Geilenfeldt shoreline setback variance

**COASTAL ENGINEERING
AND
ENVIRONMENTAL ASSESSMENT
FOR
SHORELINE SETBACK VARIANCE APPLICATION**

Richard and Sharon Geilenfeldt
TMK 8-4-10:11, LOT 313
84-135 Maka'u Street
Wai'anae, Hawai'i 96792

VI. RESPONSE TO DRAFT EA REVIEW COMMENTS

Figure 3. Inundation of Makau St. during Hurricane Iniki, 1992.
Photograph by Carl Viti, The Honolulu Advertiser

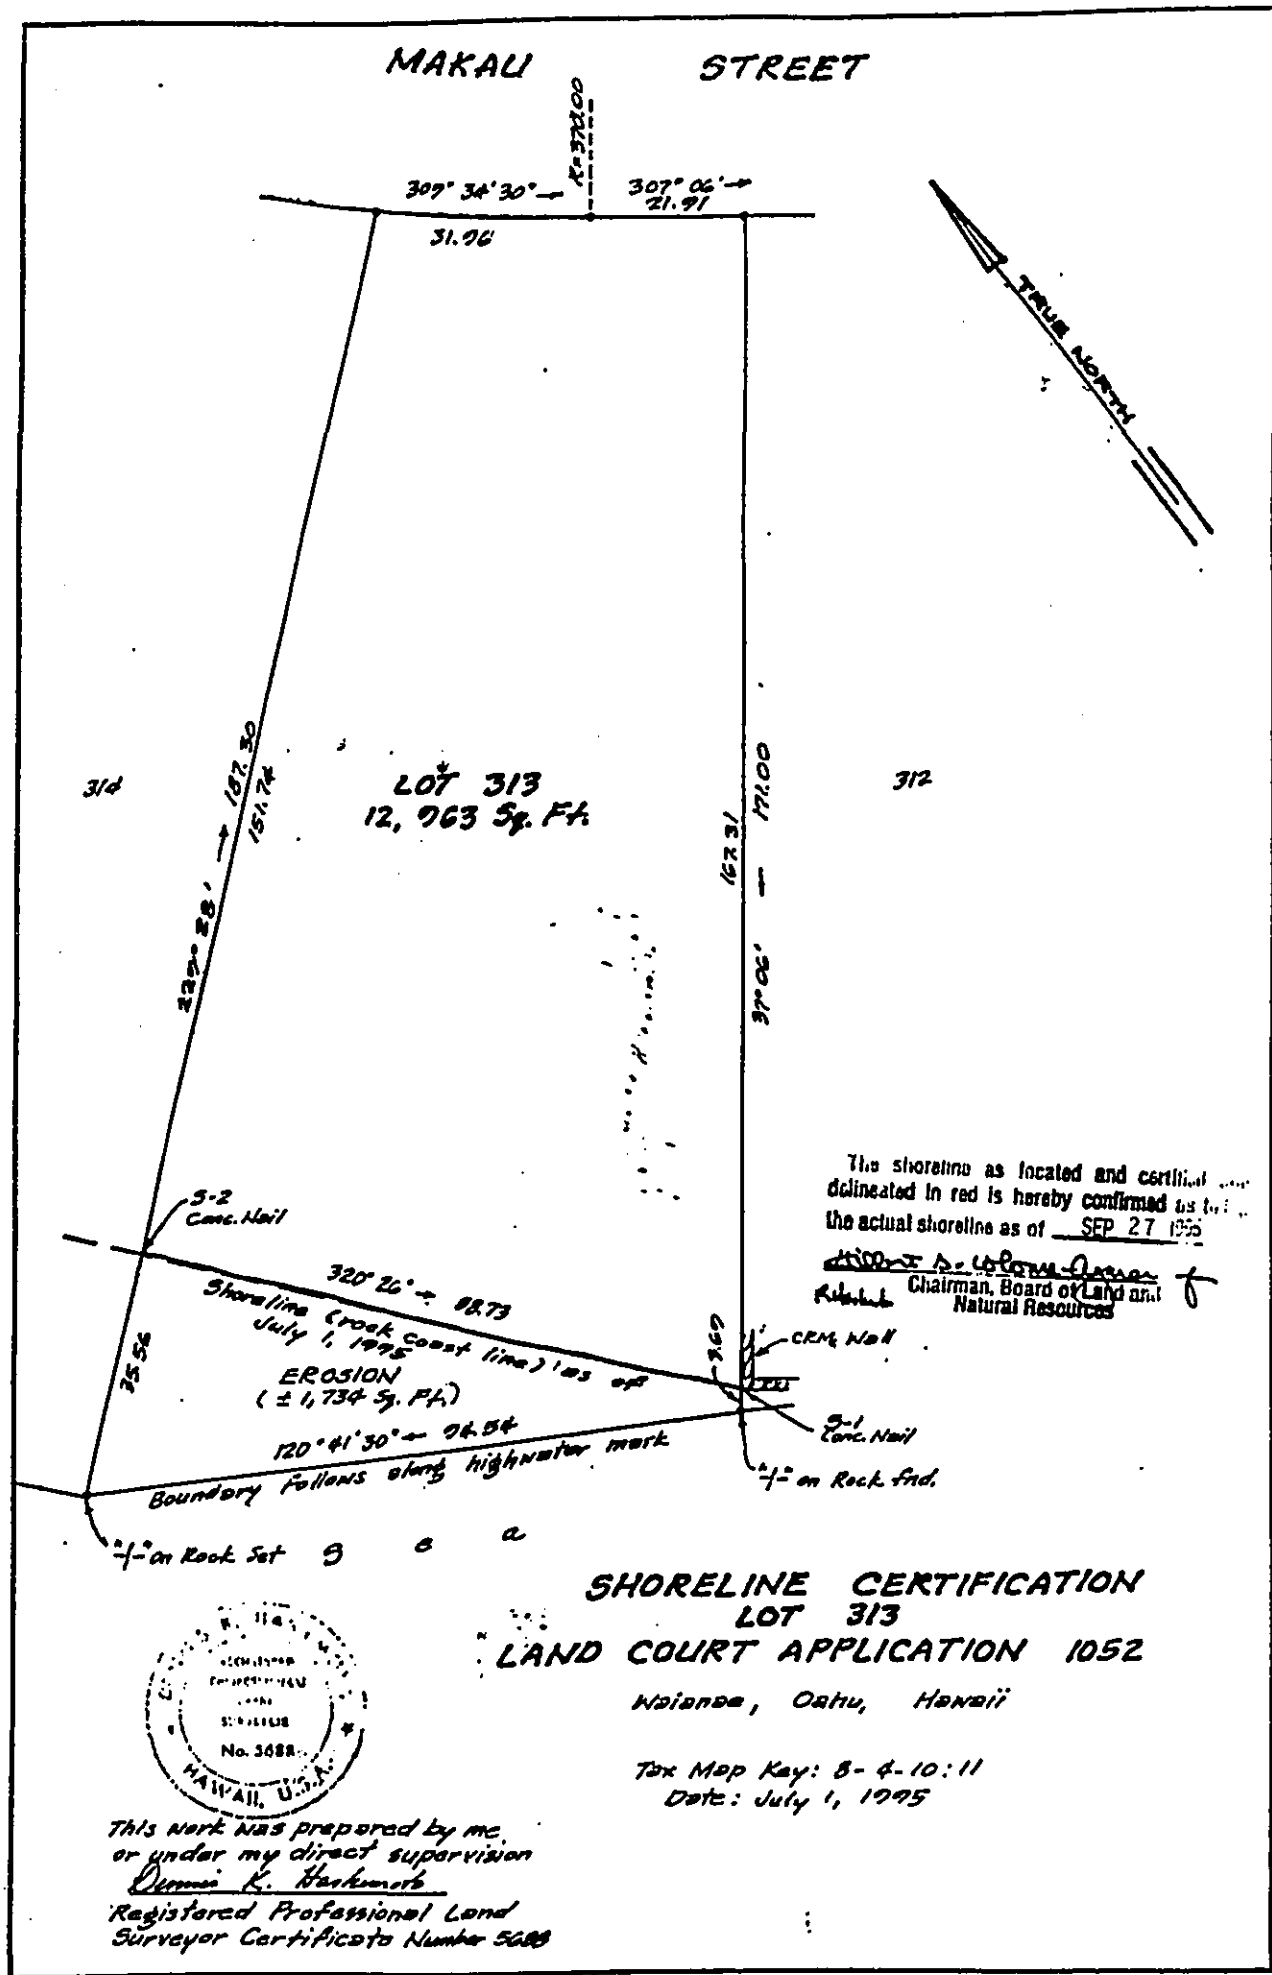
Response 10: As illustrated in Figure 3, extreme storms such as Hurricane 'Iniki can result in significant wave action in the project area. Any structure built in this area would risk significant damage if it were not protected by a hard structure such as a seawall or a revetment. That is why all shoreline homes in the neighborhood are protected by seawalls. Alternatives to shoreline hardening are therefore not feasible at the project site. To ease concerns about the location and height of the proposed seawall, the owner is proposing relocating the wall 20 feet landward of the certified shoreline and reducing the height to 6 feet (Figures 9 and 10).

Figure 5. Plan view of project site with geologic features

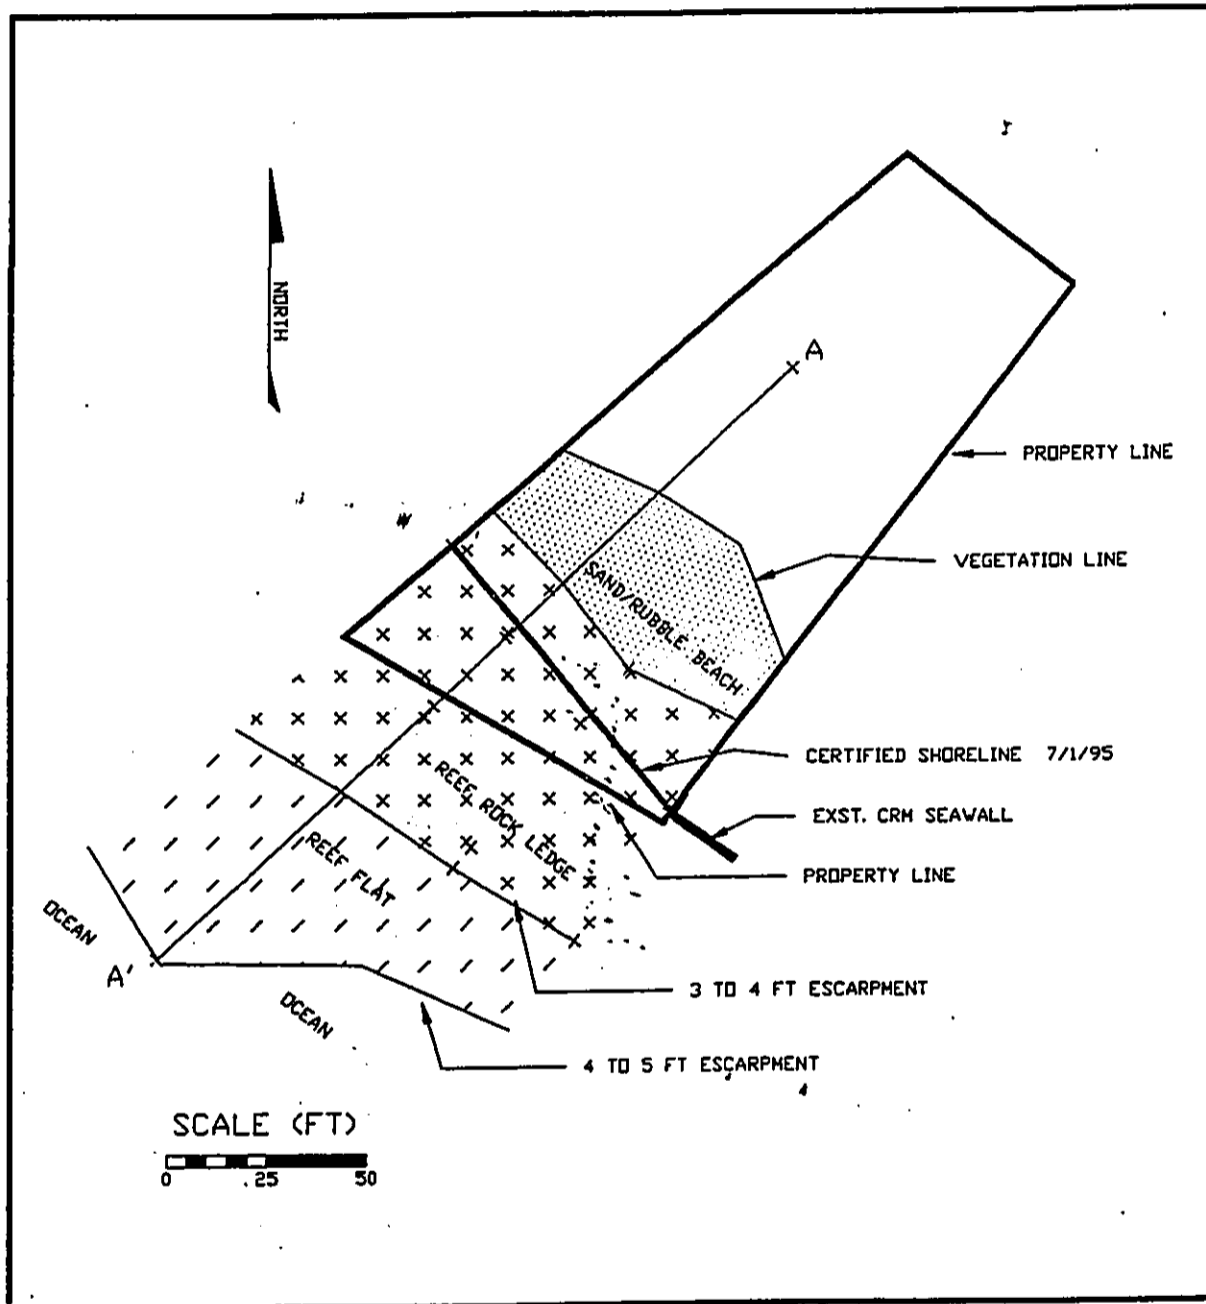
Despite the requirements of State law and State rules, Figure 5 of your Draft Environmental Assessment (EA) shows that the vegetation line on the Geilenfeldt's vacant lot is generally more than 40 feet inland from the July 1, 1995 "certified shoreline".

Response 1: It is not correct to say that the certified shoreline was negotiated and is not "the upper reaches of the wash of the waves". The vegetation line in Figure 5 is the result of severe waves produced during Hurricanes 'Iniki and 'Iwa, and does not represent the upper reaches of the wash of the waves other than storm waves. The certified shoreline is considered a reasonable estimate of the upper reaches of the wash of the waves. For a more detailed discussion of the location of the certified shoreline, see Response B.12.

Figure 9. Typical cross-shore profile with proposed structures

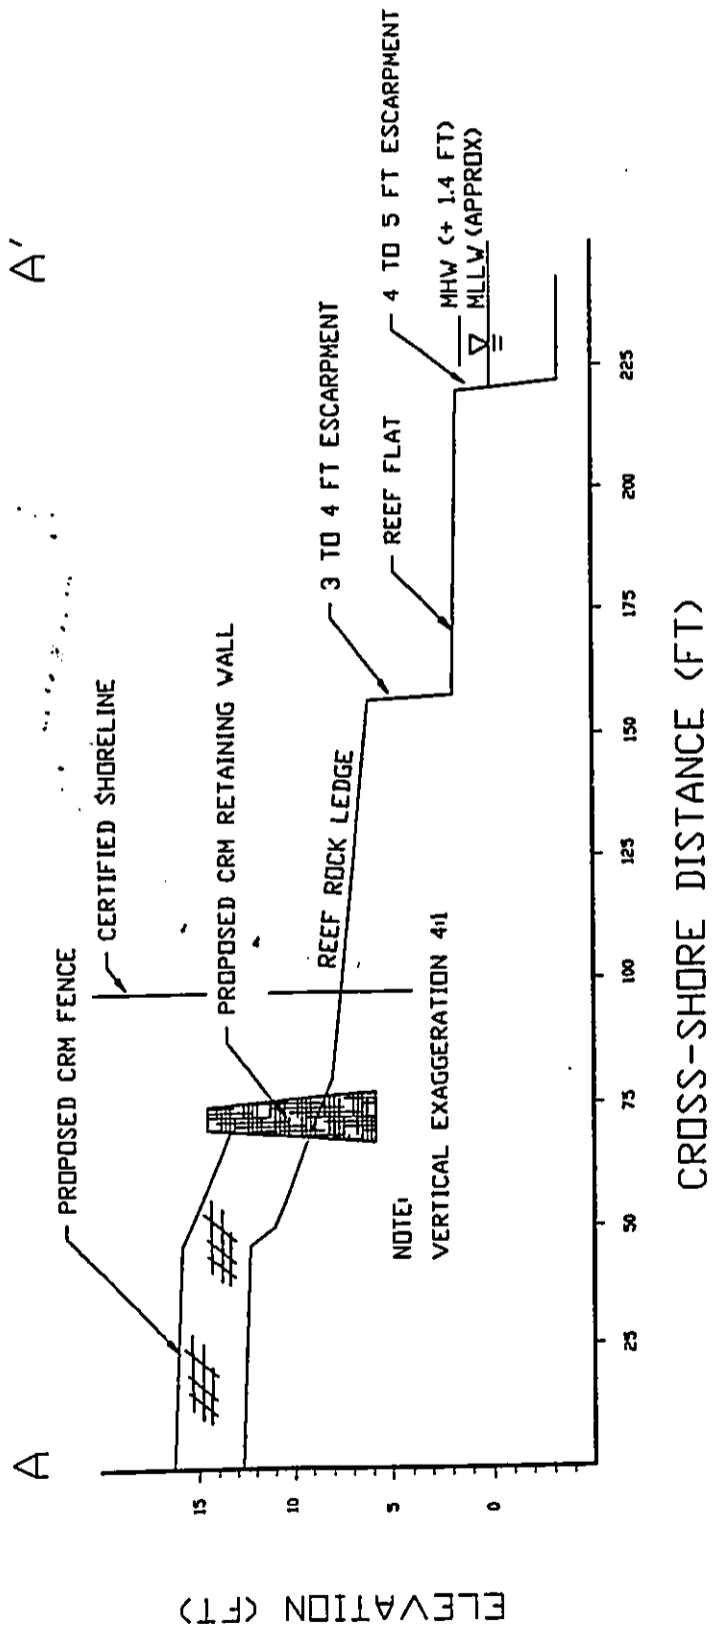
5. The site plan and cross-section plans must be drawn to scale. Wall cross-sections should be identified on the site plan.
6. The plans which you have submitted indicate that the wall will exceed the maximum height established in the Land Use Ordinance. As such, a height variance will also be required.

Figure 10: Site Plan

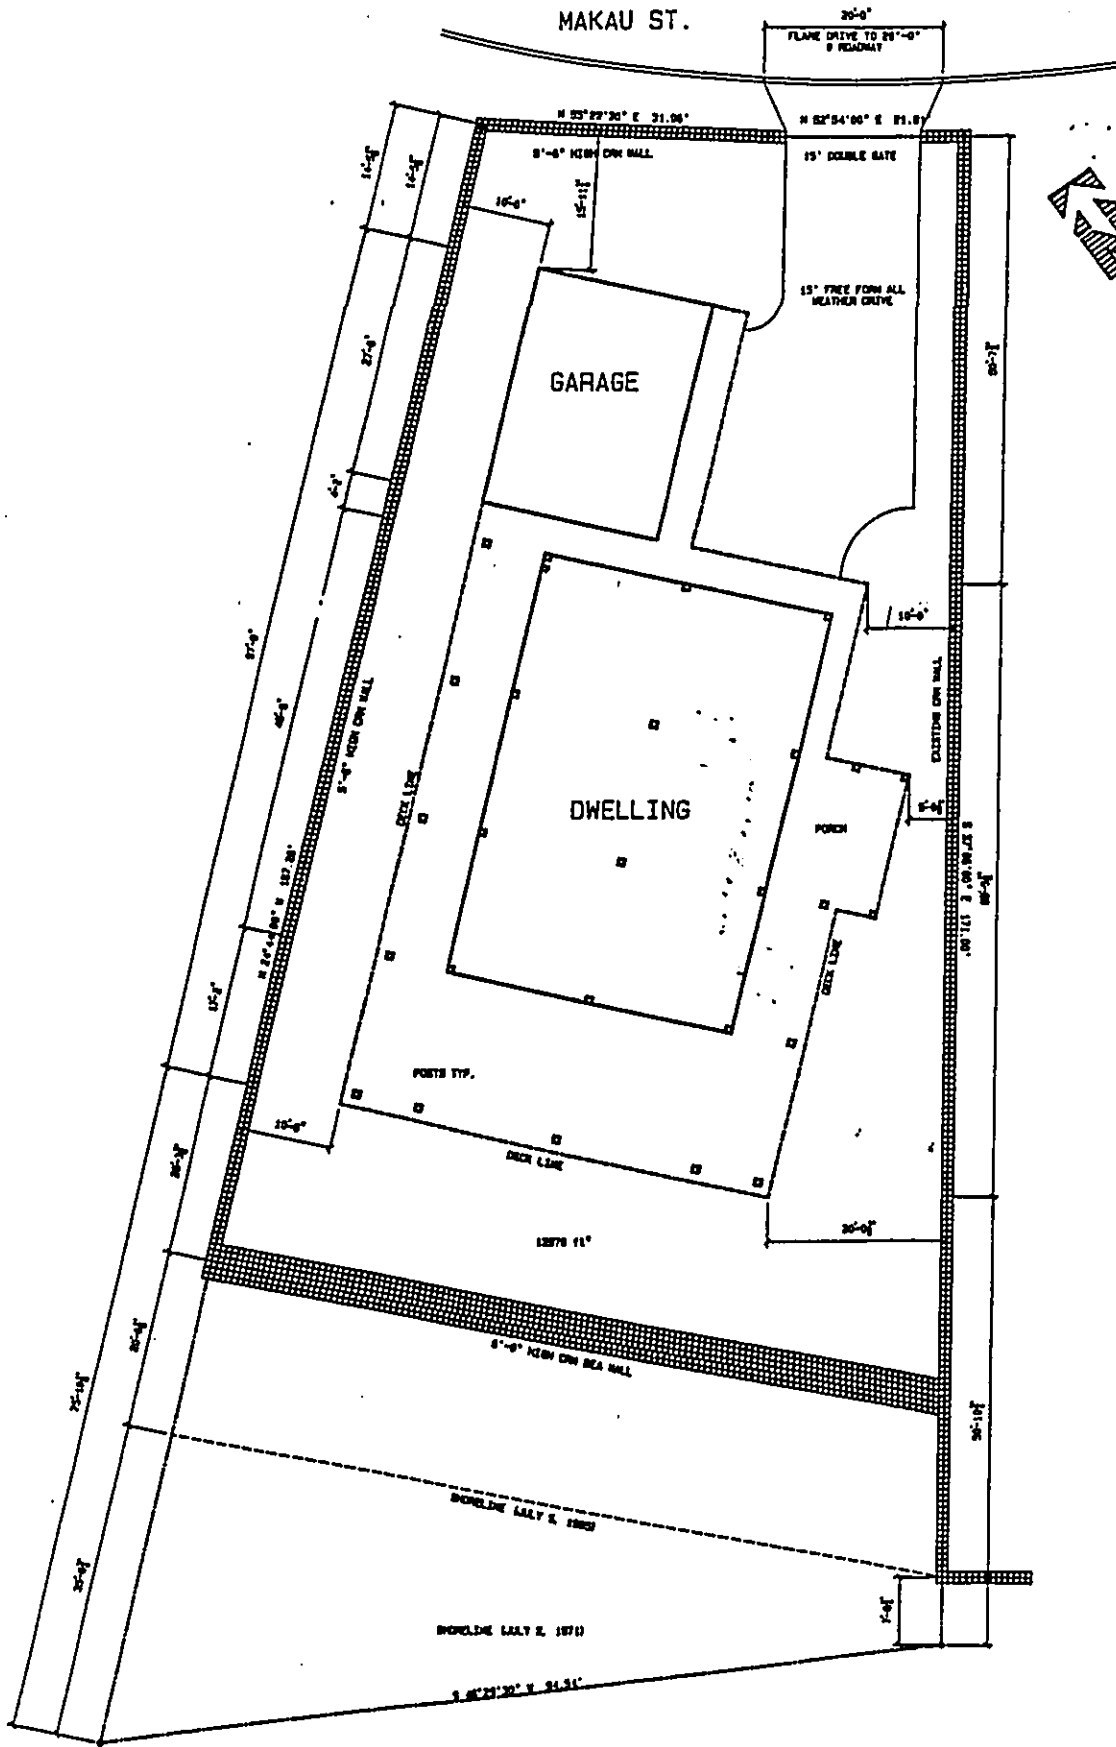
Response 6: Figure 10 illustrates the home planned for the lot.

Response 11: The landowners are planning to build a house on the property. The planned footprint of the house is shown in Figure 10.

Response 3: see EA, Figures 4, 5, 9 and 10. The previous certified shoreline is the property line shown on Figure 4, and is also shown in Figure 10. Figure 10 has been added to show the future house to be built on the site. Public access easements are shown on Figure 2.
